AGENDA
CITY OF KENTWOOD PLANNING COMMISSION
TUESDAY, NOVEMBER 26, 2024
KENTWOOD COMMISSION CHAMBERS
4900 BRETON AVENUE, SE
7:00 P.M.

RE: ***Raising Cane's
Site Plan and Special Land Use Review
3650 – 28th Street
Kentwood, MI***

The responses below address the comments received on November 7, 2024 from the City of Kentwood's Engineering Department following the planning level review for the Raising Cane's Special Land Use and Site Plan Review. Below is a summary of the actions taken in response to these comments.

RAISING CANE'S C1283
3650 28TH SE
CITY OF KENTWOOD
KENT COUNTY, MI 49512

C7.0
SHEET NO.

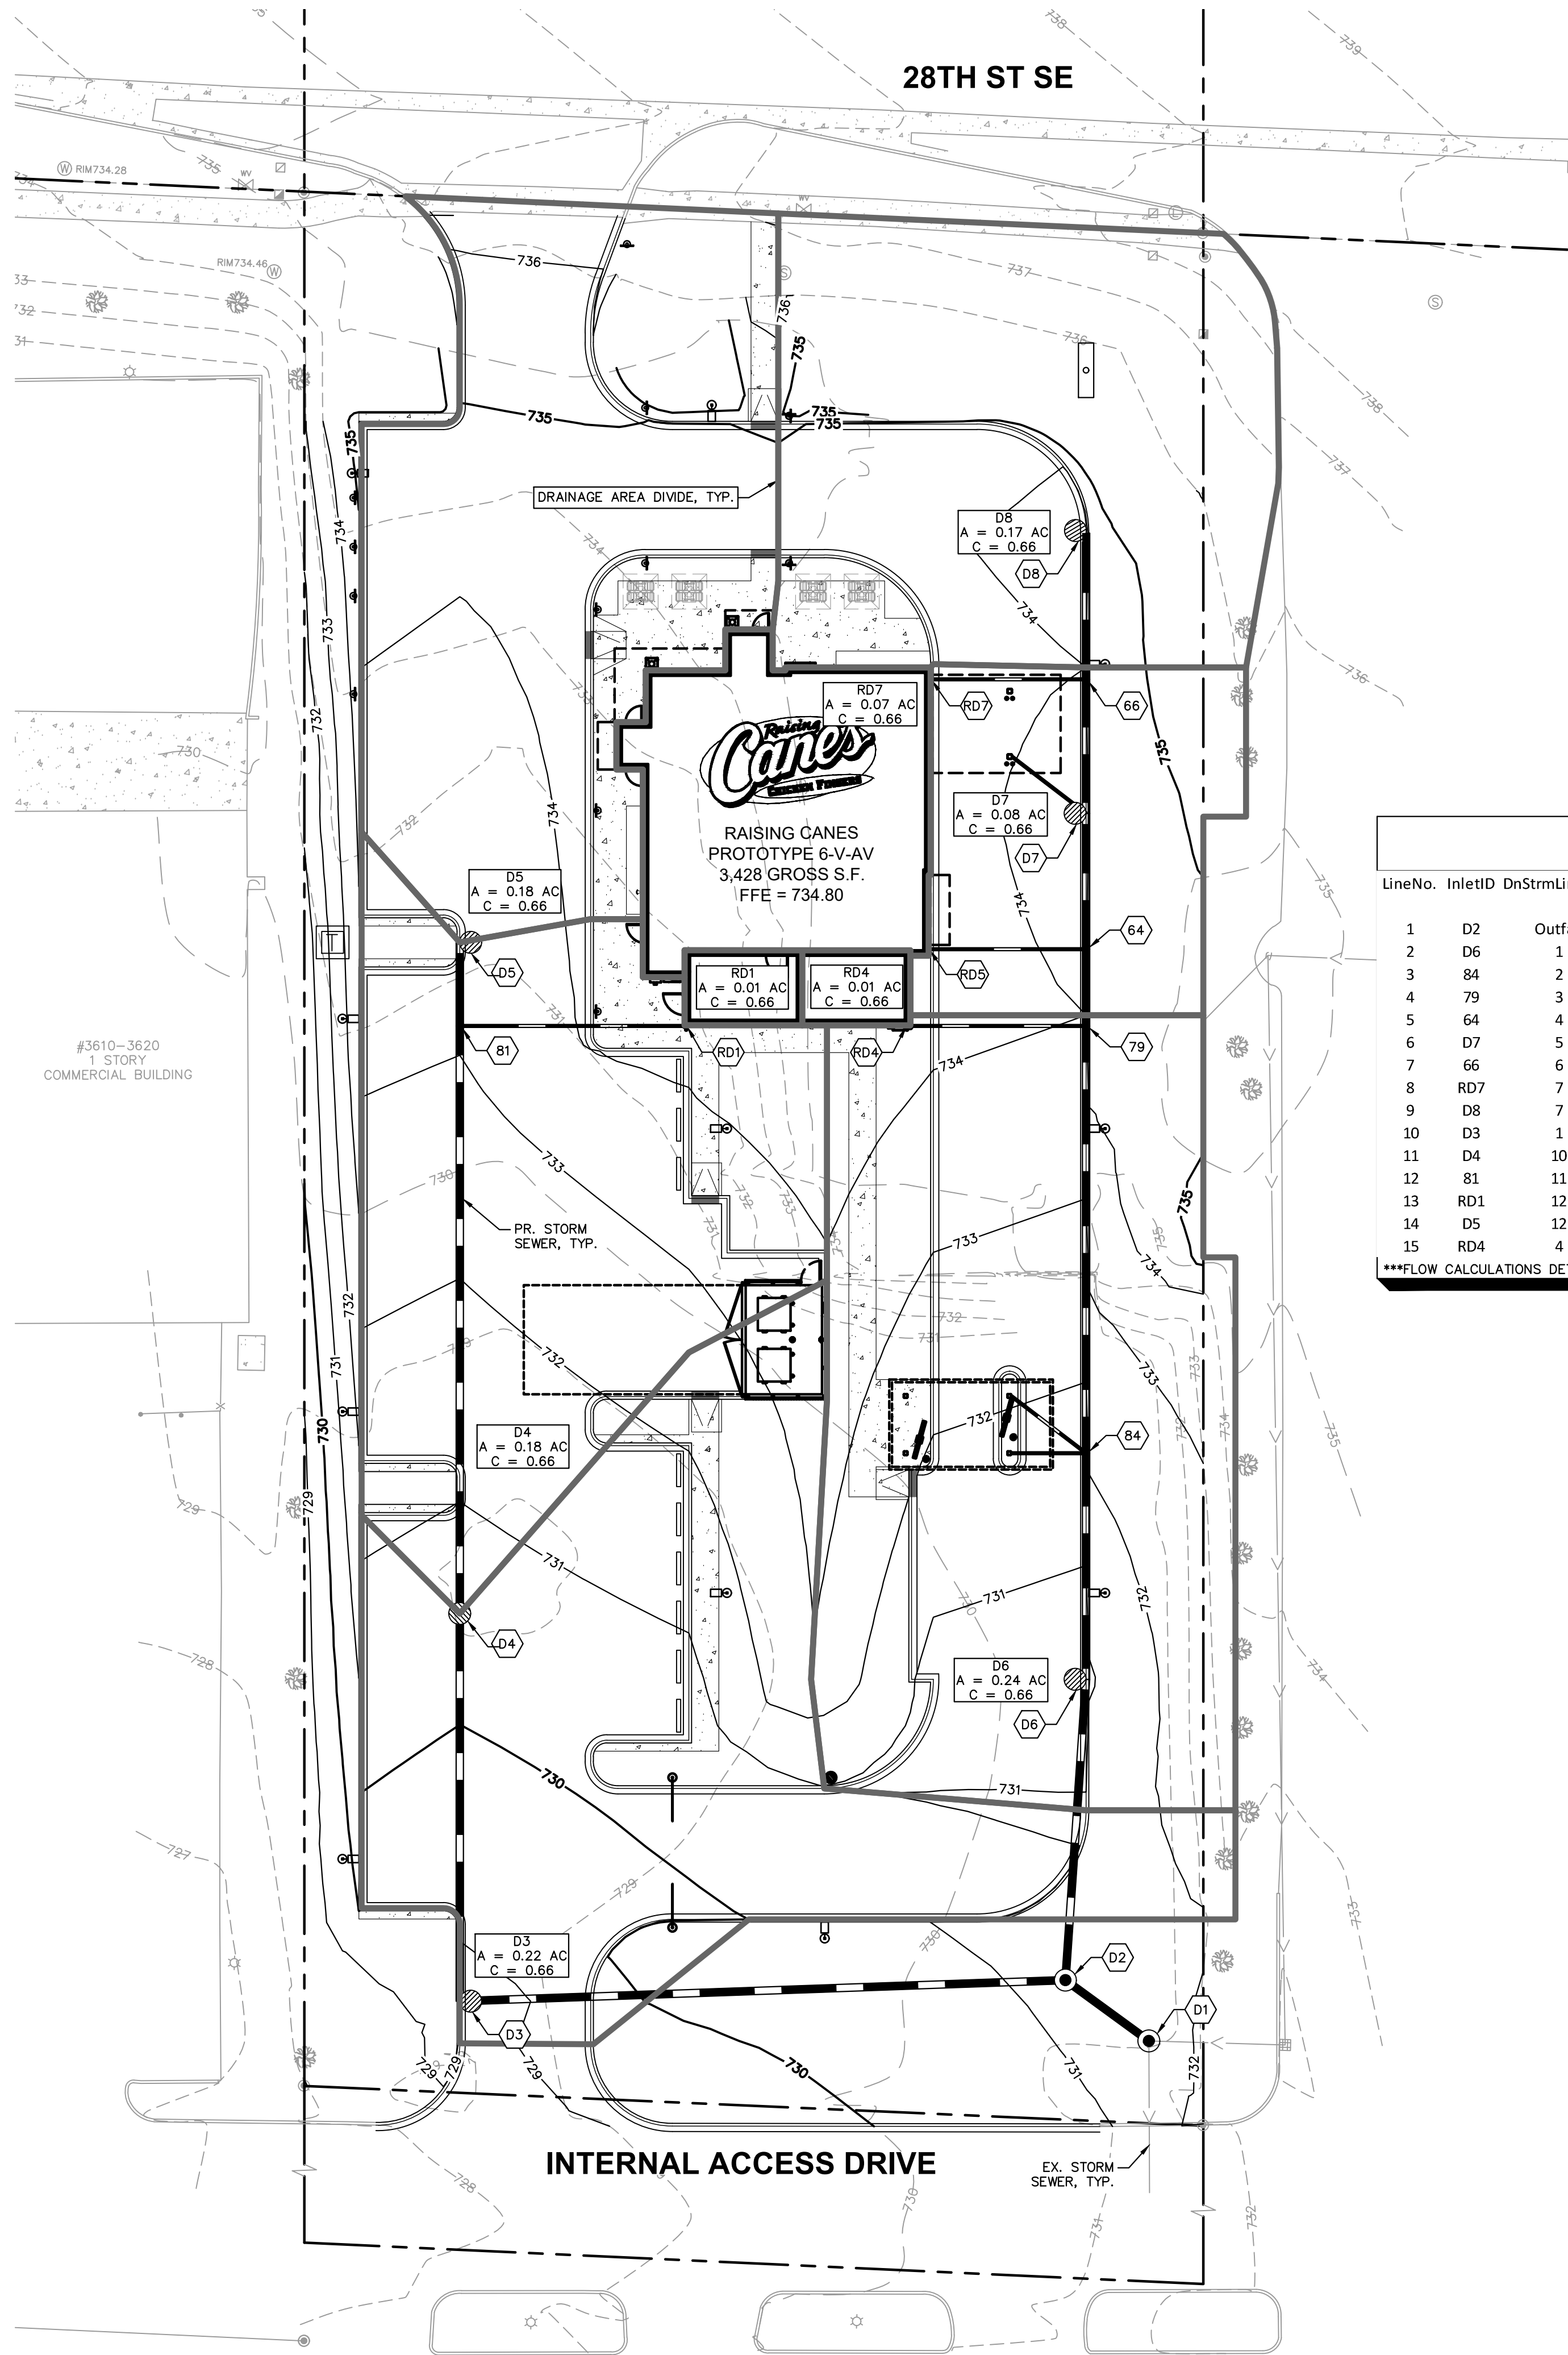
1. The City of Grand Rapids owns, operates and maintains the sanitary sewer collection and water distribution systems in this portion of Kentwood. Any alterations, extensions or new connections to either of these systems will require approval from Grand Rapids. Construction plans (drafting standards) and specifications for the proposed watermain and sanitary sewer must conform to Grand Rapids requirements.

Response: Note added to the City of Kentwood Utility Notes section on the utility plan on C7.0.

STORM SEWER NOTES

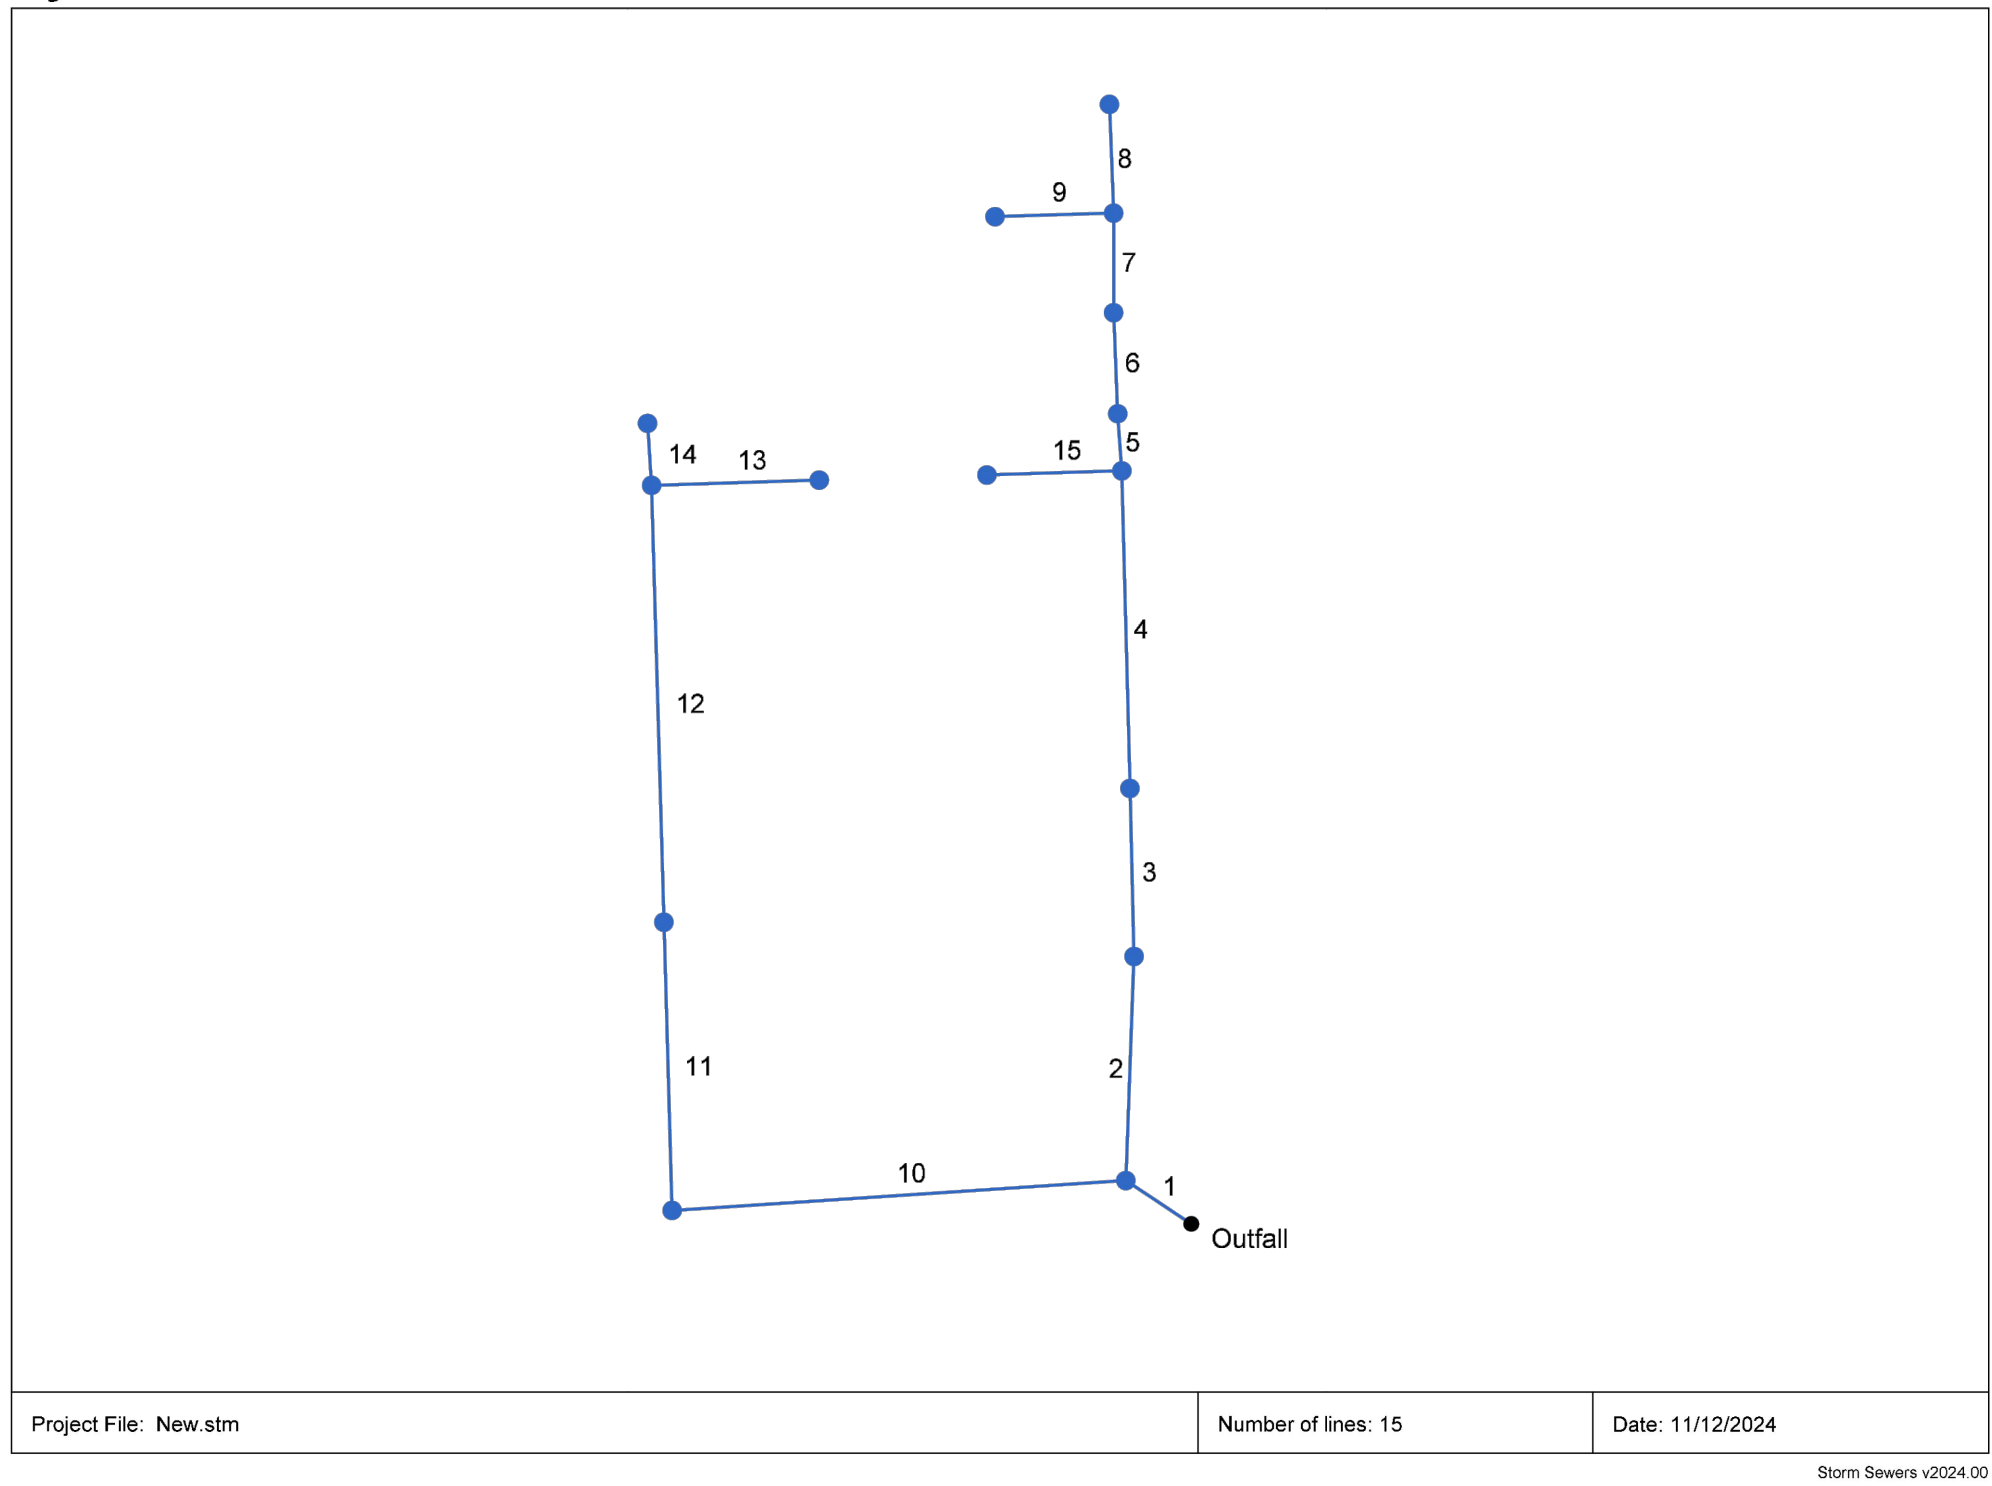
1. Provide a tributary area map and calculations to verify the capacity of the proposed and existing storm pipes to carry a 10-year storm (or a 100-year event if no overland floodway is provided). Use the Kentwood Storm Sewer Design Standards available on the City's website; they contain a Kentwood-specific IDF curve and time of concentration (T_c) nomograph. Use a minimum initial T_c of 10 minutes. Maintain a minimum cleansing velocity of 2.5 ft/sec in the pipes. Calculations must be sealed by a registered engineer.

Response: A tributary area map and calculations are included in this submission on Sheet C9.0- STORMWATER CALCULATIONS. Pipes are sized to adequately carry a 10-year storm. Overland floodway is provided, see Sheet C6.0 – GRADING PLAN. Kentwood Storm Sewer Design Standards are used for the stormwater calculations.
